Subject: Issuance of Amendment No. 2 to Facility Operating License
NPF-29 Grand Gulf Nuclear Station, Unit No. 1

GRAND GULF NUCLEAR STATION, UNIT 1

AMENDMENT TO FACILITY OPERATING LICENSE

Amendment No. 2
License No. NPF-29

FIGURE 6.2.1-1 OFFSITE ORGANIZATION

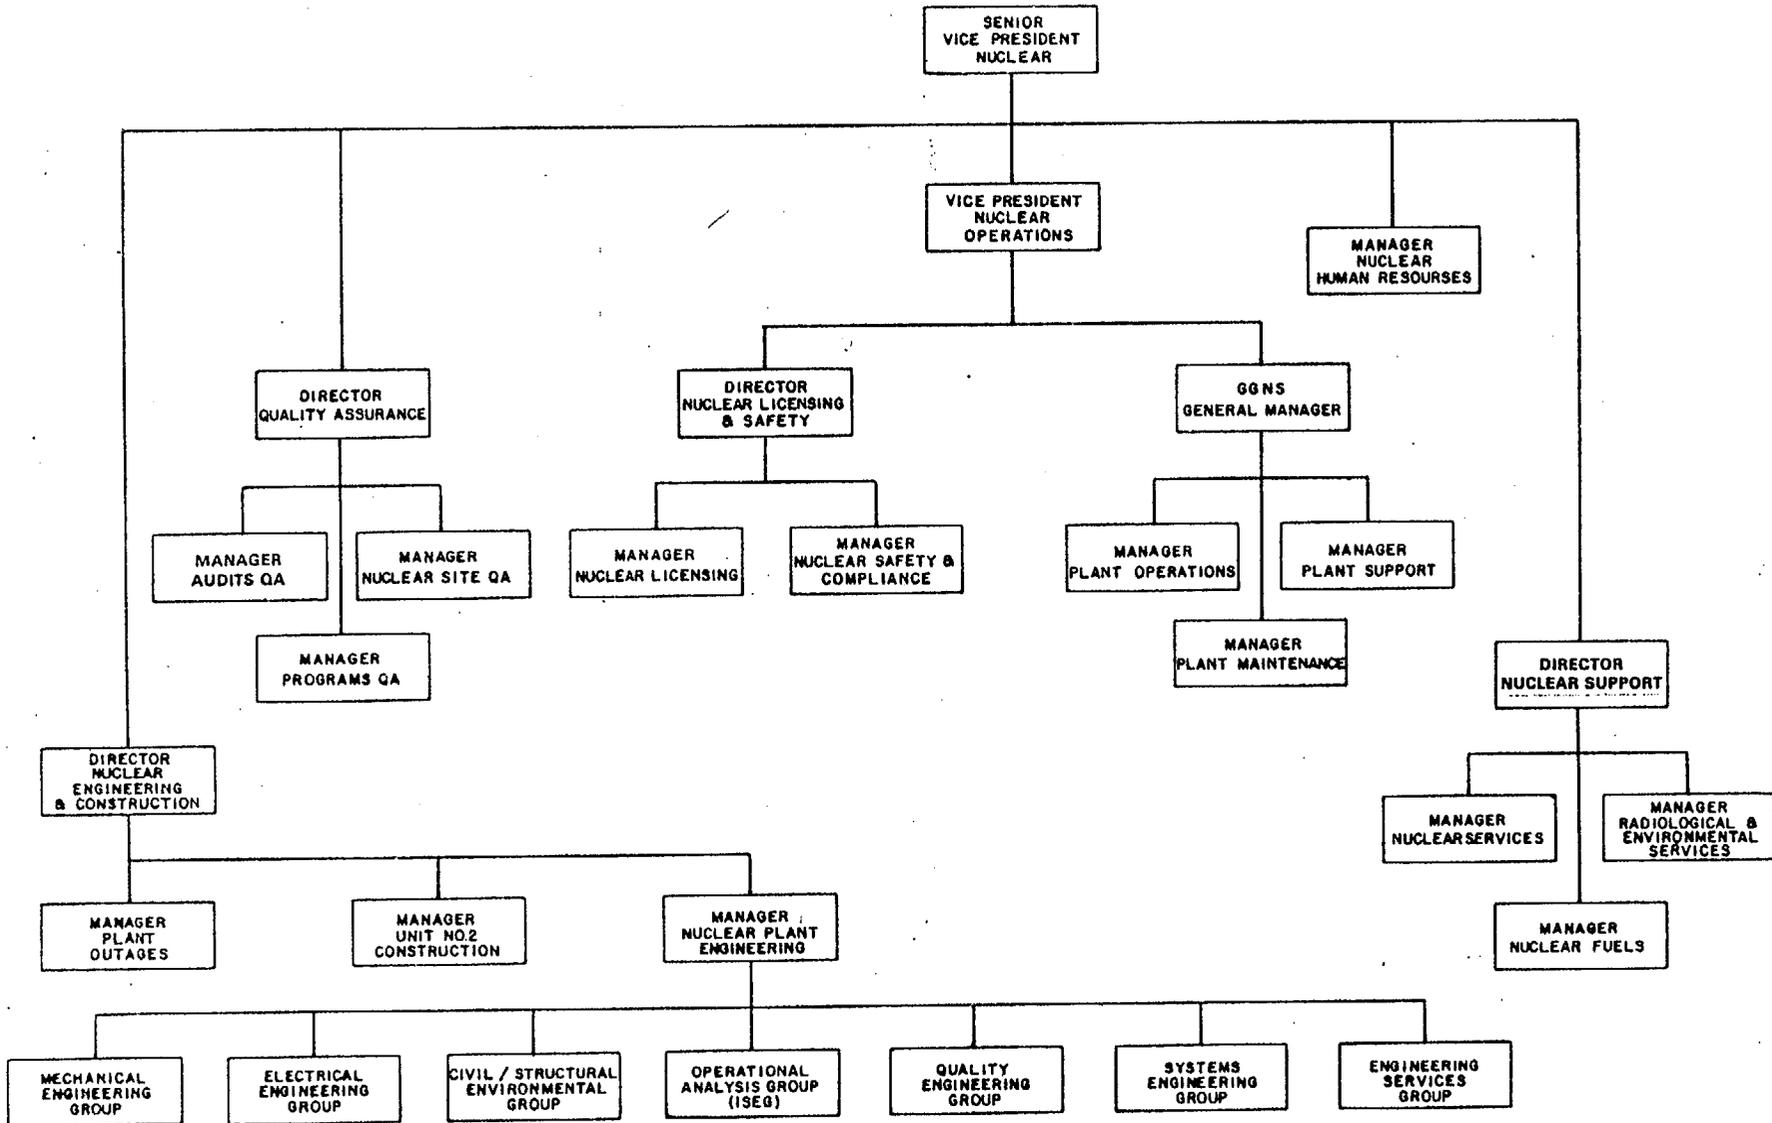
By letter dated January 30, 1985, Mississippi Power & Light Company (the licensee) proposed to change the facility Technical Specifications to implement changes in the licensee's organization which would make plant quality personnel more independent of plant operations personnel. The changes would be: (1) change the title of Manager, Supplier QA, to Manager, Audits QA, on the Offsite Organization chart; (2) delete the position of Nuclear Plant Quality Superintendent from the Unit Operating chart; and, (3) change the composition of the Plant Safety Review Committee by substituting the Manager, Nuclear Site QA, for the Nuclear Plant Quality Superintendent.

The staff has reviewed the proposed changes. Change (1) to the Technical Specifications is simply a change of title to more accurately reflect the primary responsibility of the position, while the lines of responsibility and communication are not changed. In change (2), the Nuclear Plant Quality Superintendent will be moved from the Unit Operating Organization and placed under the Manager Nuclear Site QA in the Offsite Organization in order to minimize possible conflicts of interest in the management of the plant operation. The Nuclear Plant Quality Superintendent will spend more time on his primary responsibility of quality inspection since the majority of other QA functions he has been performing, including review of procedures and procurement documents will be delegated to other QA positions having the same or higher level of responsibility. This change is an improvement in the quality assurance functions of the plant since the Unit Operating Organization Management will not have line responsibility for the quality inspection functions and the performance of other QA functions will be enhanced. In change (3), substituting the Manager, Nuclear Site QA, for the Quality Superintendent in the Plant Safety Review Committee will maintain the level of review from a quality assurance standpoint, since the Quality Superintendent reports to the Manager, Nuclear Site QA. Proposed changes (2) and (3) improve safety in that they allow QA activities to focus entirely on quality requirements and to be independent of plant production activities. Accordingly, the staff concludes that the proposed changes are acceptable.
